Access Compliance Report Public Rights-of-Way (Curb Ramps)

Intersection ID: N/A Main Street: PROVIDENCE_COUNTRY_CLUBS_ross Street: MCGILL_HEIGHTS_RD Location: NE

ADA ID: 754605341DB3 Ramp Type: Perp Initial Pass/Fail: Fail Overall Compliance: No Severity Score: 12.5

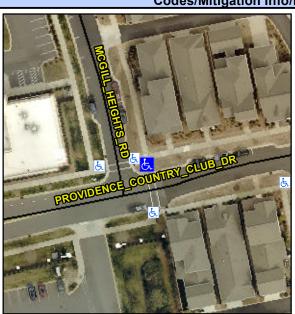
Possible Solution			Field Measurements/Component Compliance						
Possible Solutions:			Compliance Description		Data	Compliance Description			Data
Remove & Replace Entire Ramp.		p.	N/A	Ramp Length (in)	93.0	No	Ramp	Slope (%)	9.0
